Contract No. T200301601.01
Federal Aid Project No. ESTP-K137 (2)
CARTER ROAD (K137)
Kent County

Enclosed is Addendum No. 1 for the referenced contract consisting of the following:

CARTER ROAD (K137)

SHEET NO.
79
TOTAL SHTS.
134

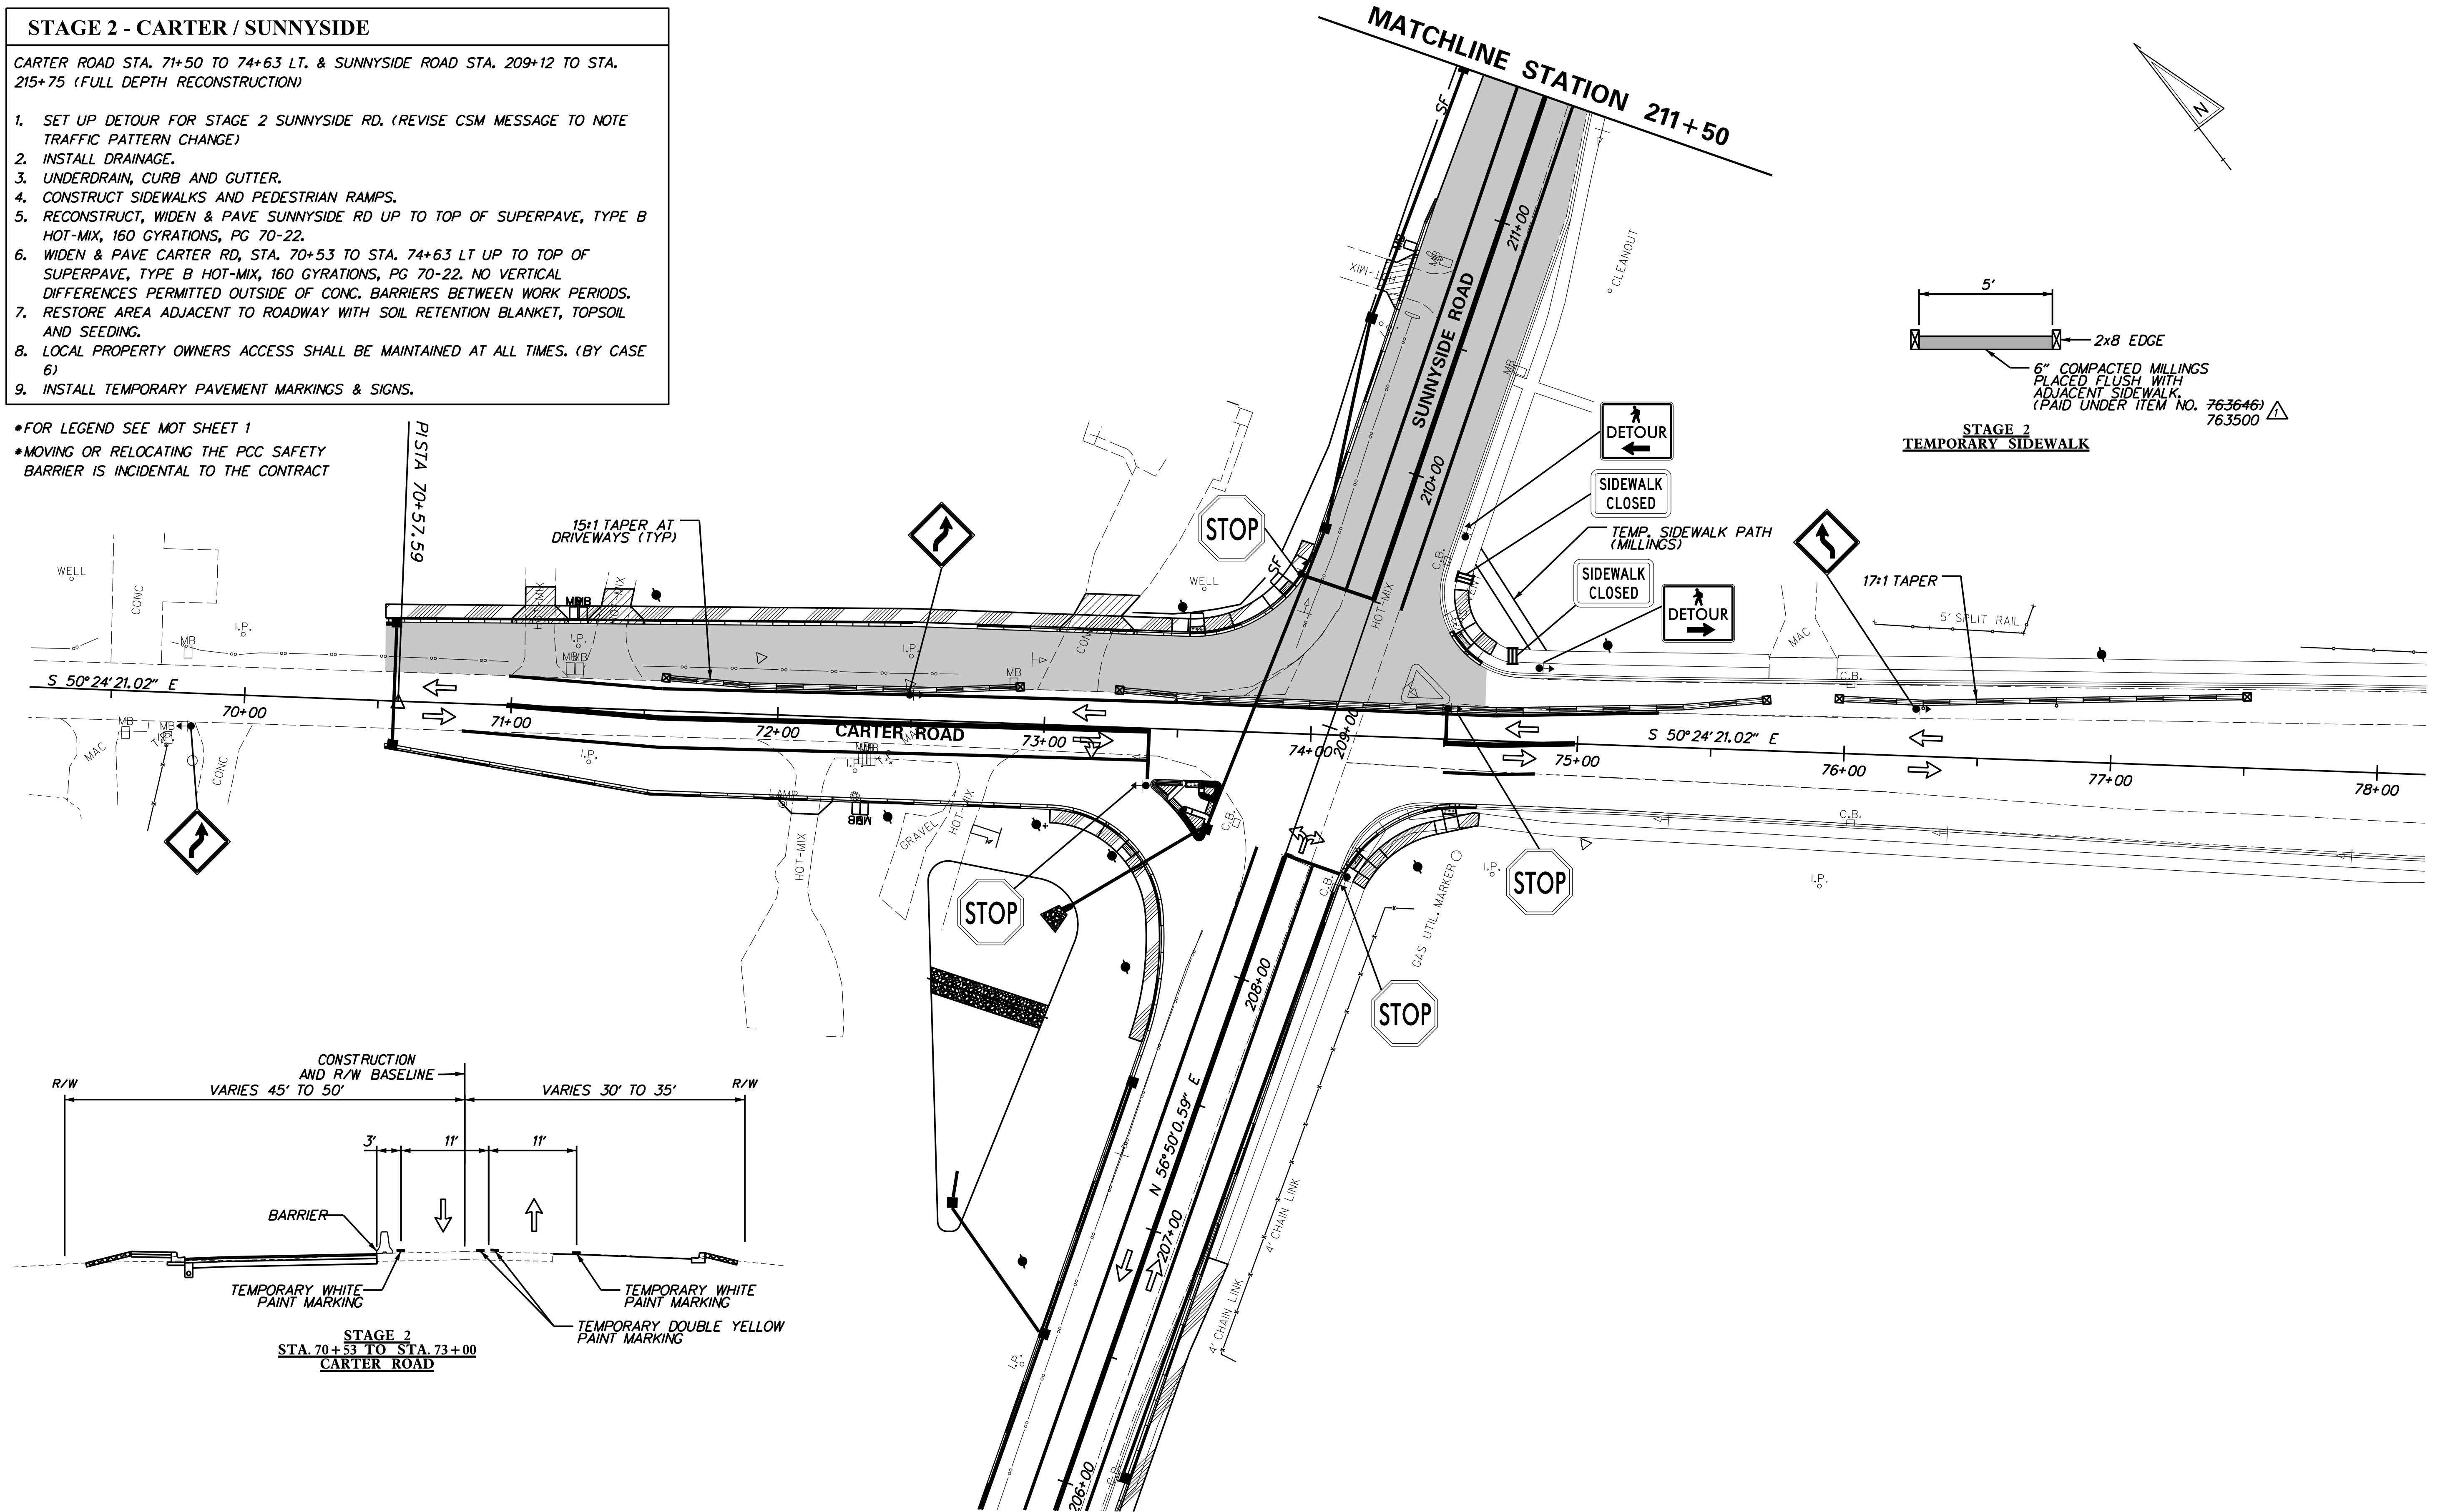
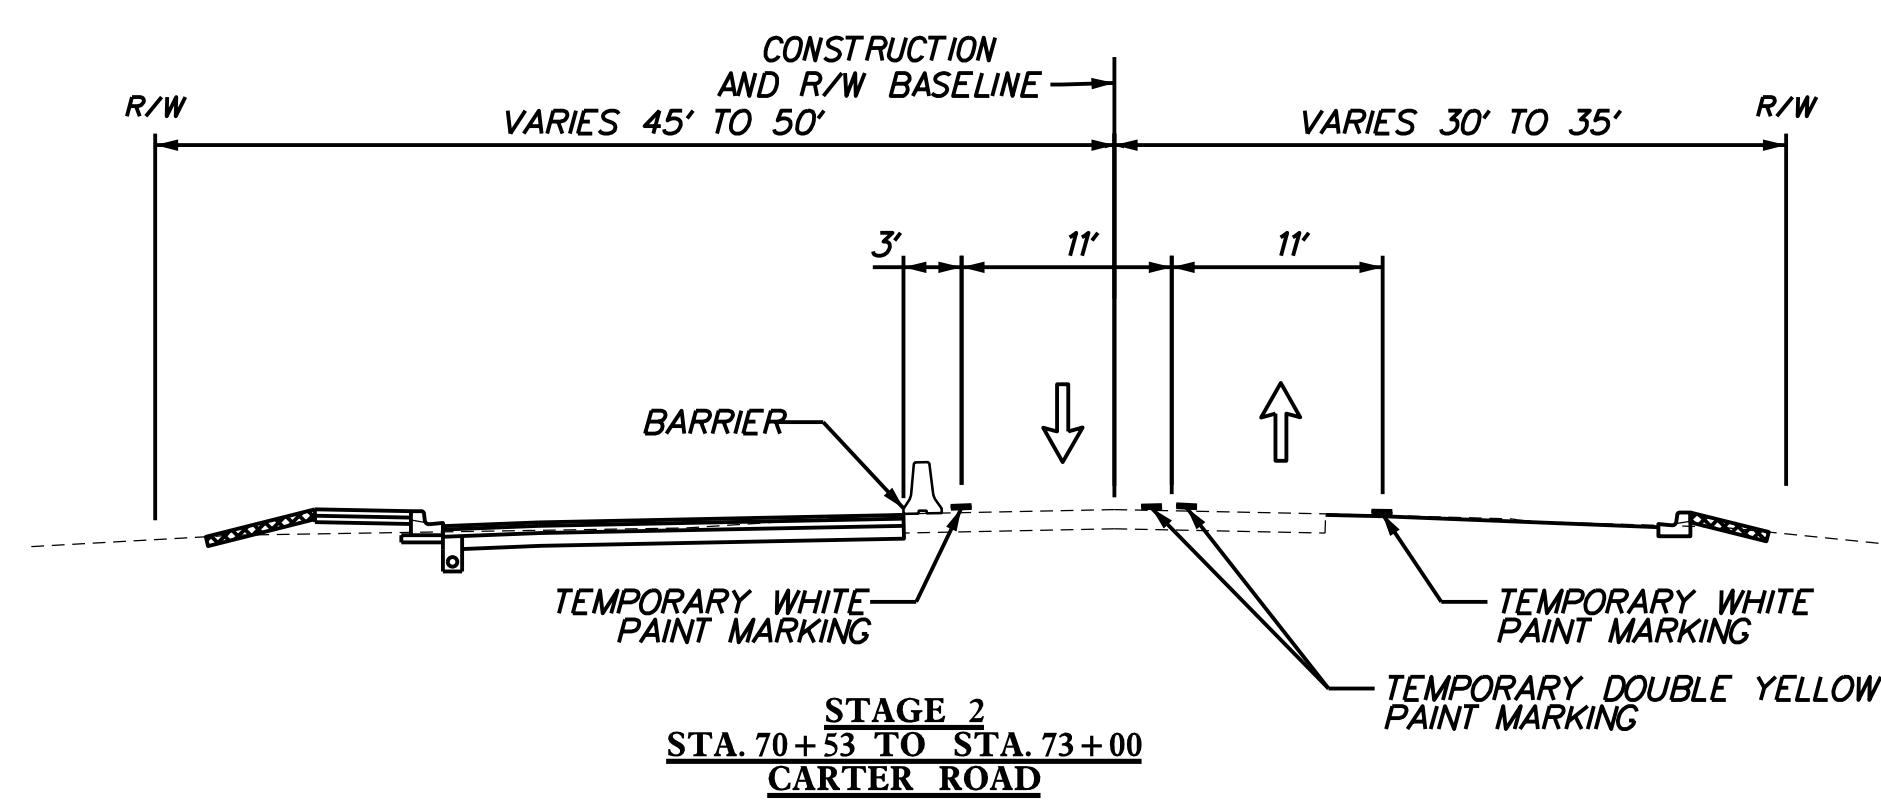
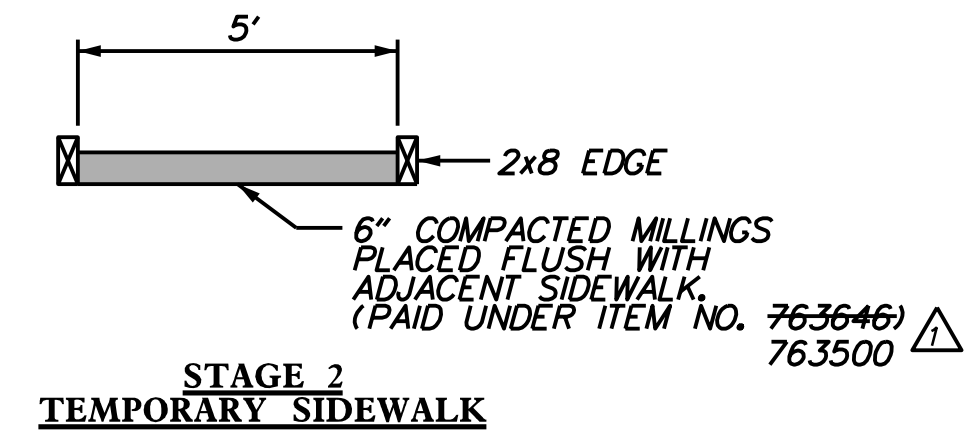
17. Sheet 79 of the plans mentions payment for millings under Item 763646. No Item 763646 in bid tabs.

26. Page 79 of Plans, Stage 2 Temporary Sidewalk, calls for payment under Item 763646. There is no Item 763646 in the proposal.

ADDENDUMS / REVISIONS	
▲	REVISED ITEM NUMBER IN TEMPORARY SIDEWALK DETAIL

The payment item number will be changed on the plans part of addendum 1 to #763500.

The payment item number will be changed on the plans part of addendum 1 to #763500.
